## **Proposal for amendments to Regulation No. 13 (Heavy vehicle braking)**

**Submitted by the expert from Denmark, coordinated and supported by the International Road Transport Union, International Commission of Technical Affairs (IRU CIT) and the Nordic Road Association, Vehicles and Transport Committee (NVF).**

The text reproduced below was prepared by the expert from Denmark, coordinated and supported by the International Road Transport Union, International Commission of Technical Affairs (IRU CIT) and the Nordic Road Association, Vehicles and Transport Committee (NVF). The text aims at improving brake distribution between truck and trailer of heavy vehicle combinations at everyday low decelerations, to enhance uniform use of all wheel brakes and thereby to counteract loss of full brake performance. The text is based on informal documents GRRF-71-18 and -19 distributed during the seventy-first session of the Working Party on Brakes and Running Gear and is based on ISO 20918 International Standard "Road vehicles - Braking threshold pressures for heavy commercial vehicle combinations with fully pneumatic braking systems". The modifications to the existing text of the Regulation

Diagram 1

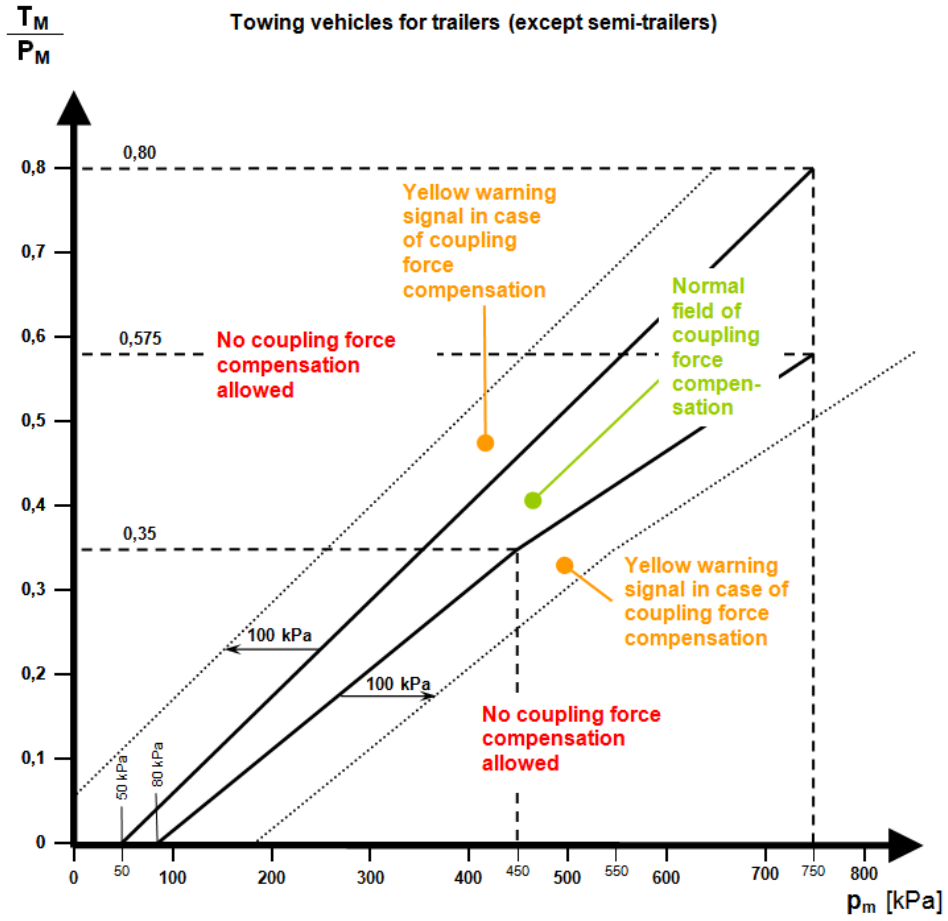
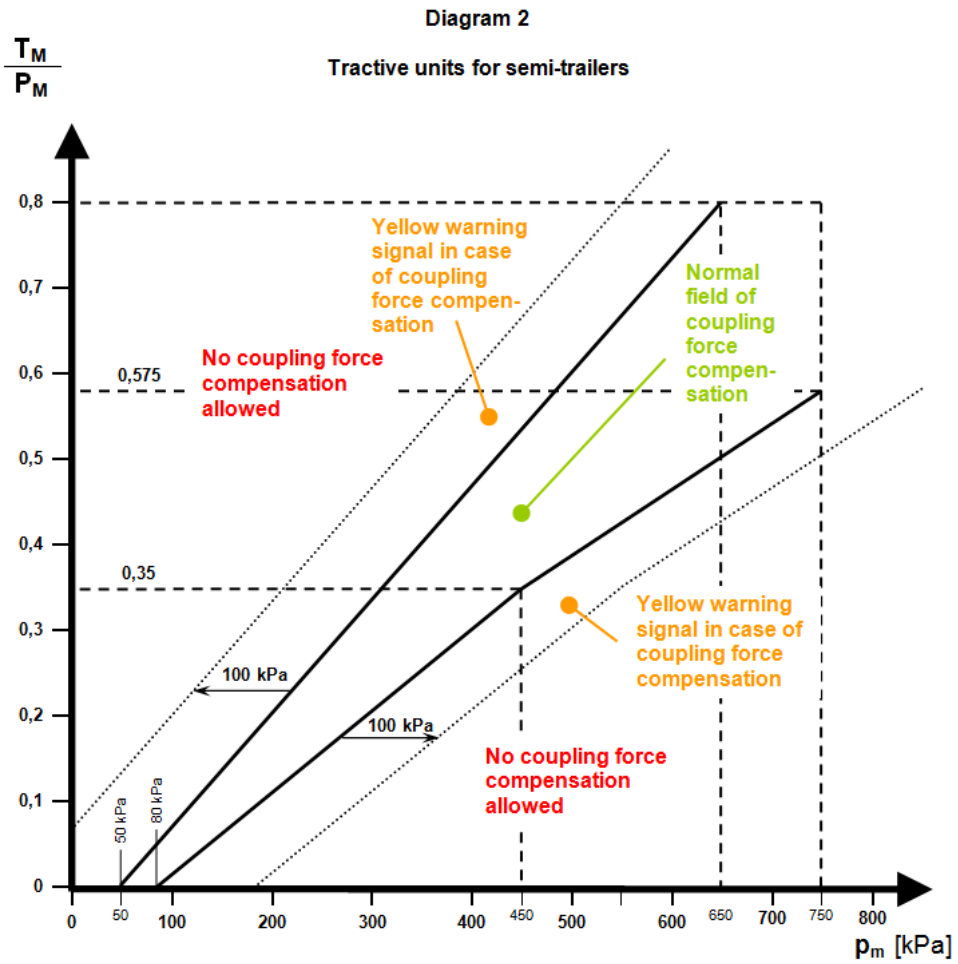
Paragraph 5.2.1.28.5., amend to read:

**5.2.1.28.5. The coupling force control system shall tend to minimise the coupling force. Max. allowed compensation by the coupling force control system is 100 kPa below the lower limit of the compatibility band and 100 kPa above the upper limit of the compatibility band as specified in Annex 10. If this compensation causes the operating point to lie outside the compatibility band as specified in Annex 10 for the motor vehicle the yellow warning signal specified in paragraph 5.2.1.29.2 shall be activated. After recoupling no compensation is allowed before the coupling force control system has registered a difference between the braking rates of the vehicles in the combination.**

**DIAGRAM 2**

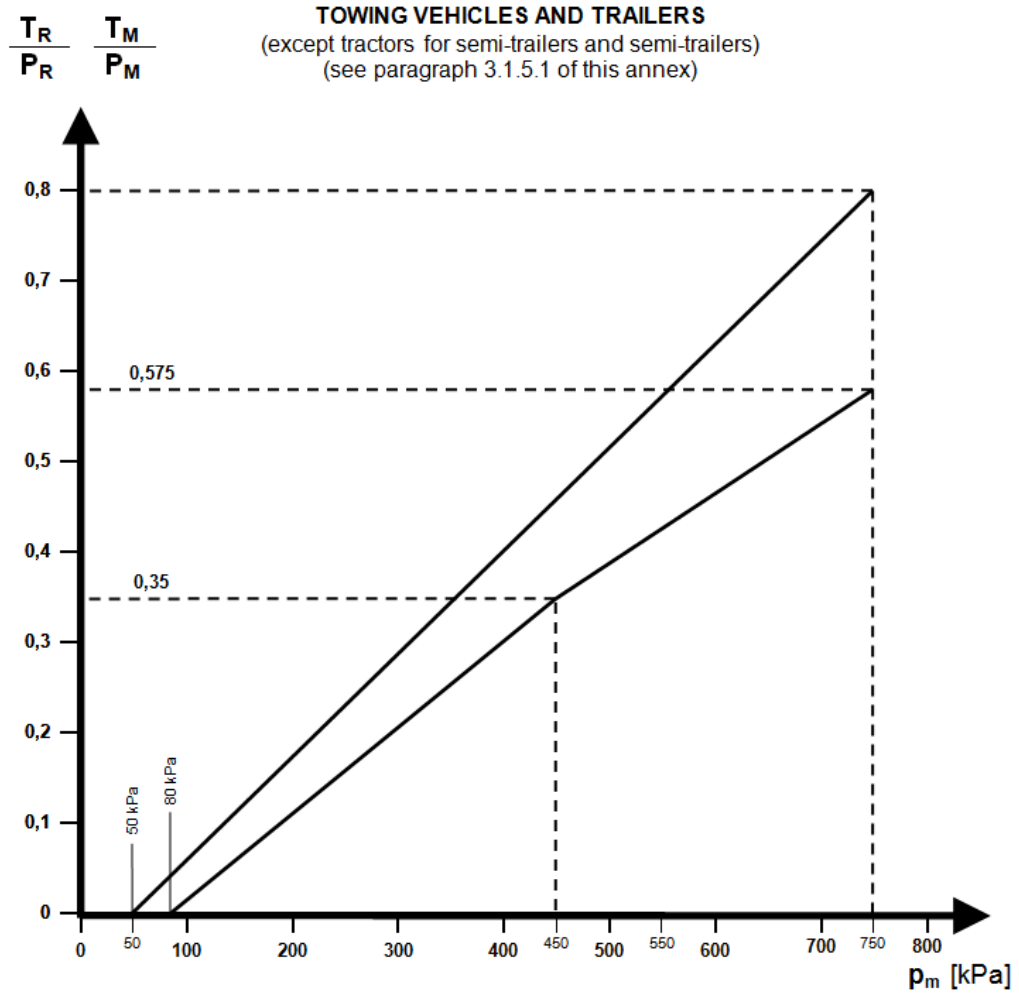
Annex 10, diagrams 2, 3 and 4A, amend to read:

**DIAGRAM 3**

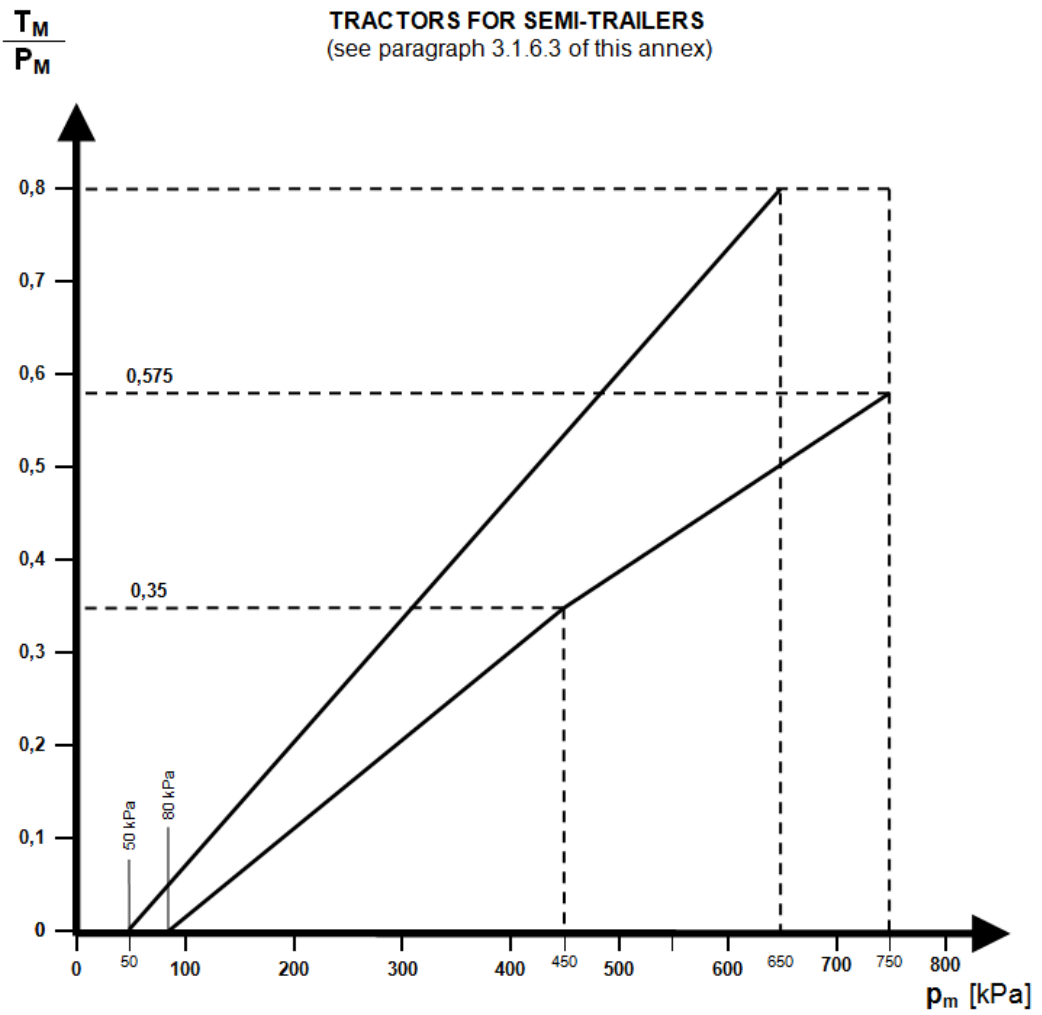
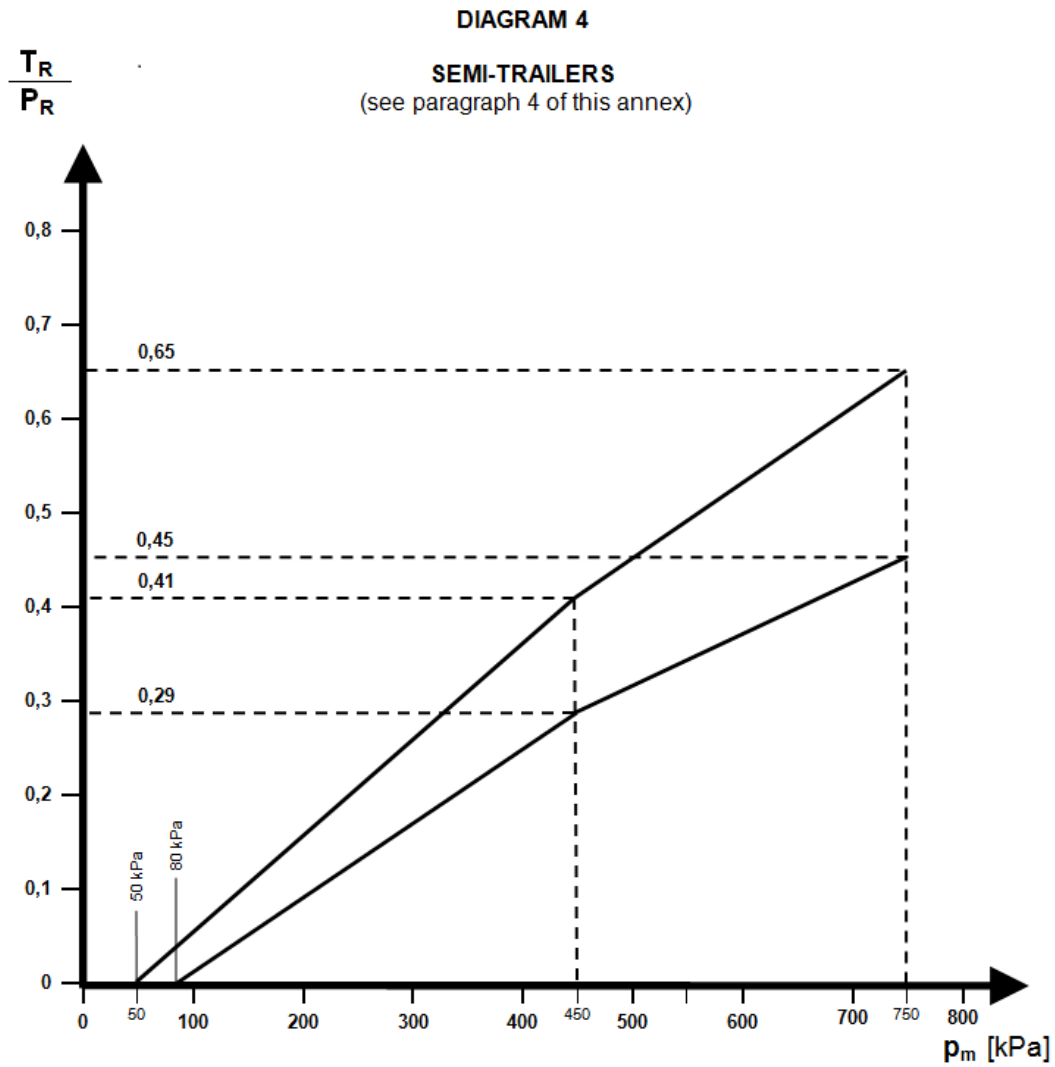
**TRACTORS FOR SEMI-TRAILERS**  
(see paragraph 3.1.6.3 of this annex)

Note: The relation between the braking rate  $T_R/P_R$  and the control line pressure is determined as follows:

To determine the **hatched** area the values of the ordinates of the upper and lower limits in diagram 4 are multiplied by the factor **K**. The factor **K** is obtained by **the calculation formula described in the following**.

DIAGRAM 2

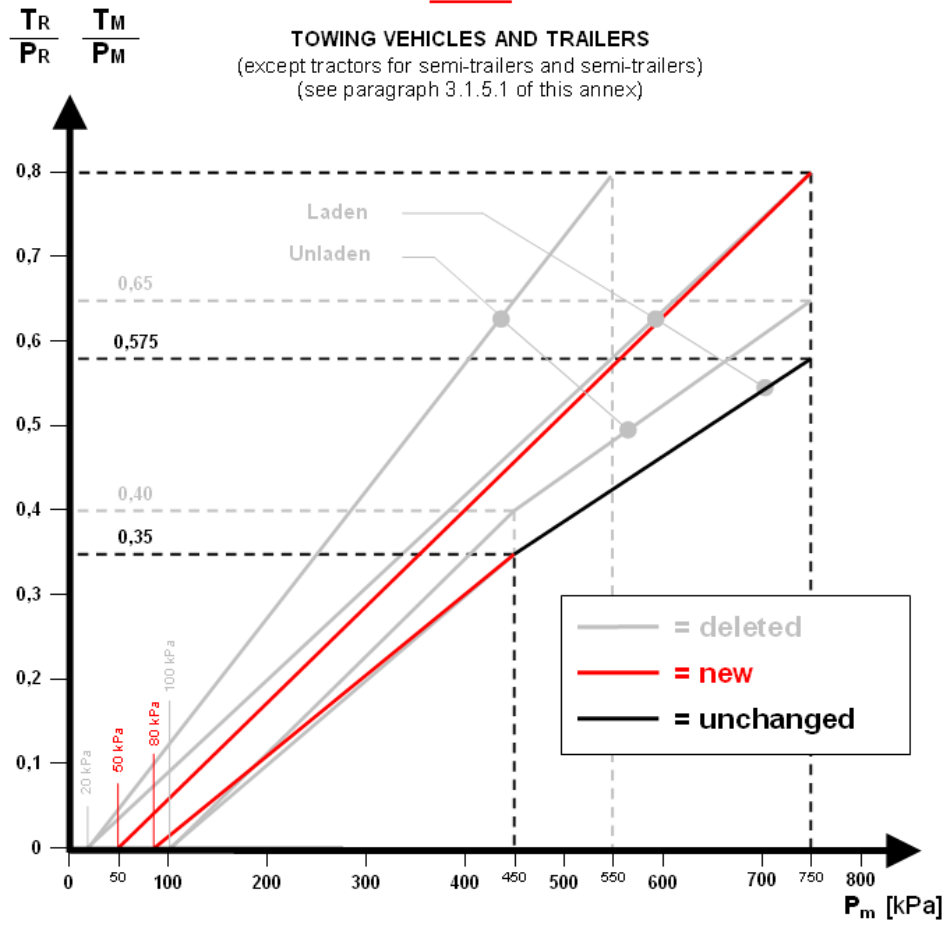
The following diagrams show the difference between the existing diagrams and the new proposed diagrams:

Annex 10, diagram 2, 3 and 4A (compatibility):

**Revised**

**DIAGRAM 3**

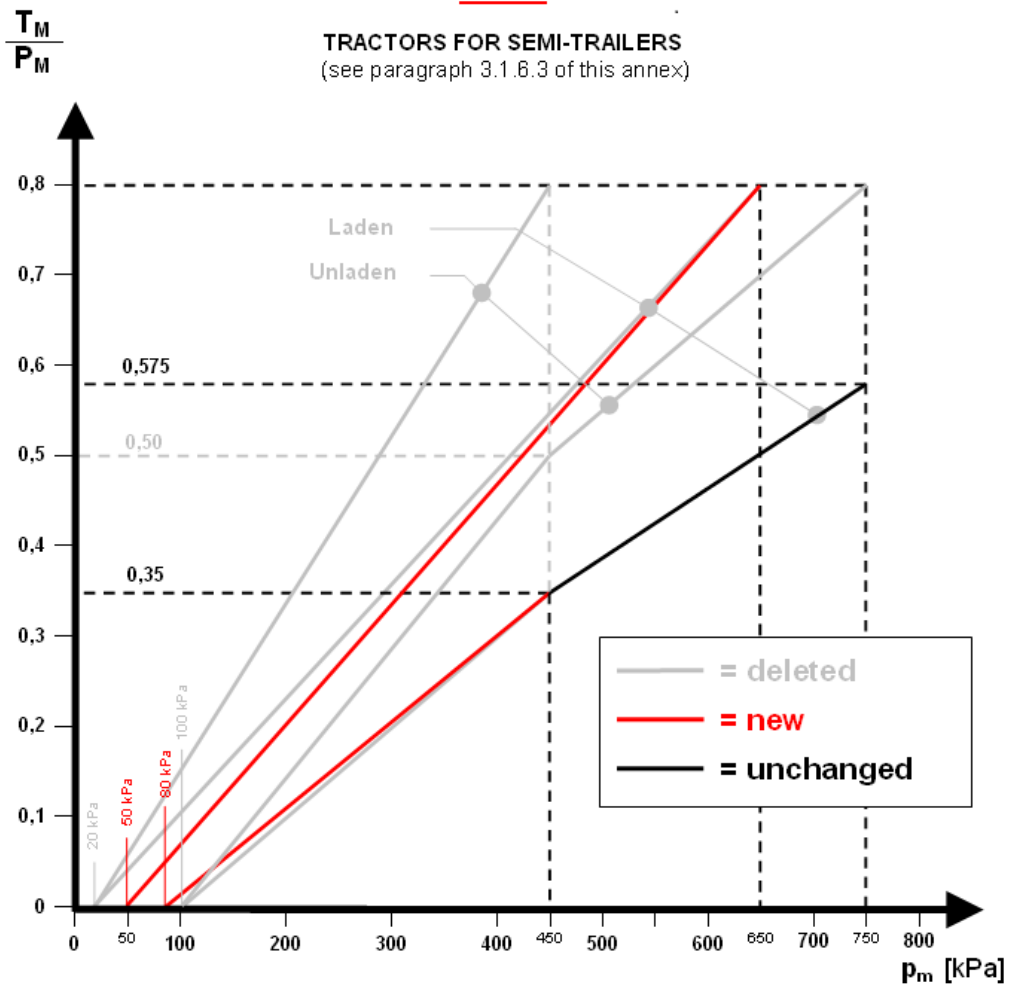
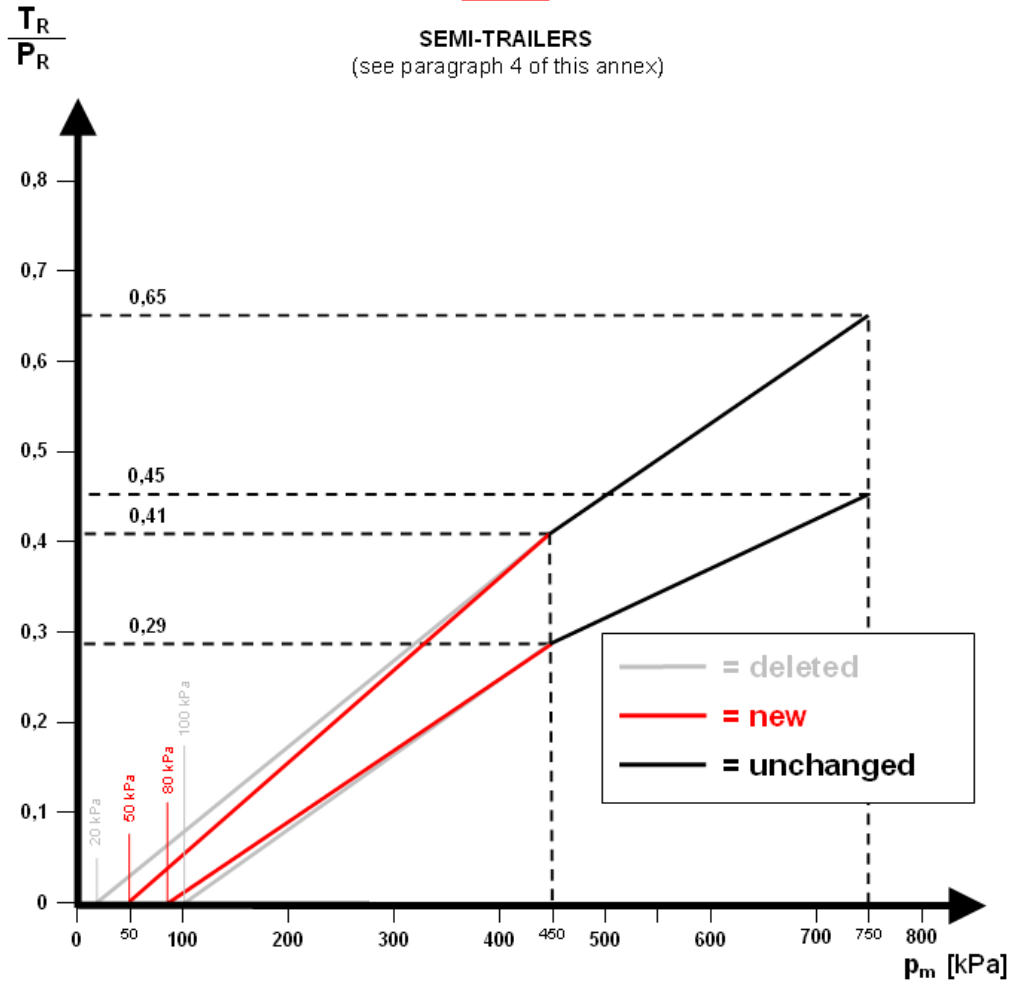
**Revised**

**TRACTORS FOR SEMI-TRAILERS**  
(see paragraph 3.1.6.3 of this annex)

DIAGRAM 4B

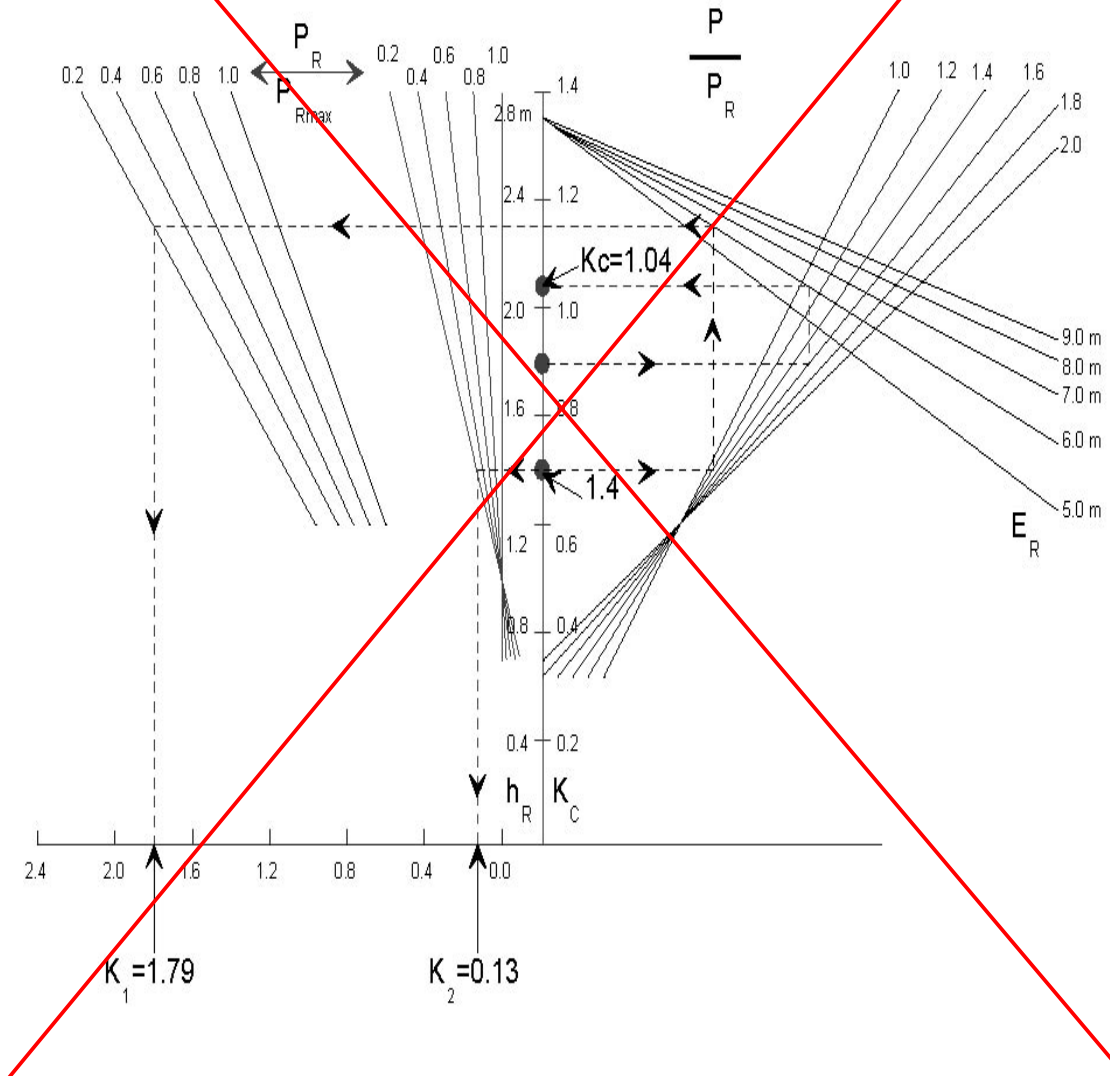
Note: The relation between the braking rate  $T_R/P_R$  and the control line pressure ~~for the laden and unladen conditions~~ is determined as follows:

To determine the ~~hatched areas corresponding to the laden and unladen conditions~~, the values of the ordinates of the upper and lower limits ~~of the hatched area~~ in diagram 4A are multiplied by the factors  ~~$K_e$  and  $K_v$  respectively~~. The factors  ~~$K_e$  (laden),  $K_v$  (unladen)~~ are is obtained by the calculation formula described in the following. ~~reference to diagram 4B.~~

1. Formula ~~from which diagram 4B is derived~~ for determination of the factor **K**:

$$K = 1.35 - \frac{0.96}{E_R} \left( 1.0 + (h_R - 1.2) \frac{g \cdot P}{P_{Rmax}} \right)$$

2. Description of method of use with practical example.
- 2.1. The ~~broken lines shown on diagram 4B refer to the determination of the~~ factors **K<sub>e</sub>** and **K<sub>v</sub>** is determined for the following vehicle, where:
